Product Change Notification

Date Issued :	November 08, 2022	PCN Number :	512754
Reason for Change :	Change Supplier		
Description of Change :	This notification is to inform you about change of supplier impacting the part(s) attached as per list, No changes will be made to product as part of this change.		
Reason for Short Notice :	Special Request		
Assessment of Change :	Supplier Qualification Test Report/s		
Planned Implementation Date :	February 19, 2023		
Sample Availability Date:	January 20, 2023		
Internal Molex Qualification Date :	February 01, 2023		
Last date to request Samples by Customer :	January 31, 2023		
Traceability Code Markings / Date :	Date code

- 105162 series add alternative copper material " C5210-SH".
- Change reason: The increasing global demand has caused a global shortage of various metal. This extraordinary situation, in conjunction with an already constrained market, has caused immediate and severe disruption in the industry. Due to these supply constraints, Molex identified an internal shortage of metal supply with would create a challenge to fulfill all orders. Therefore, we identified an alternative sourcing for the product families listed above. Aft

Before change :

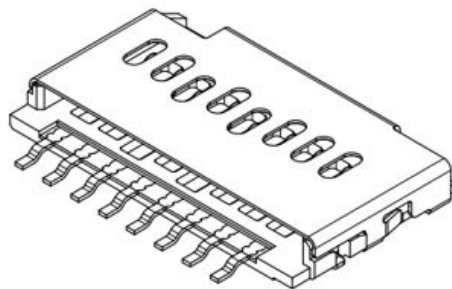
- series Add alternative copper material “ C5210-SH”.
Before change: "C5240-EH"
After change: "C5240-EH" or "C5210-SH"

1. MATERIAL: PHOSPHOR BRONZE HYPER C5240-EH,
THICKNESS: 0.12mm.

1. Material ;
a. Phosphor bronze hyper C5240-EH ,T=0.12mm.
b. Phosphor bronze C5210-SH, T=0.12mm.
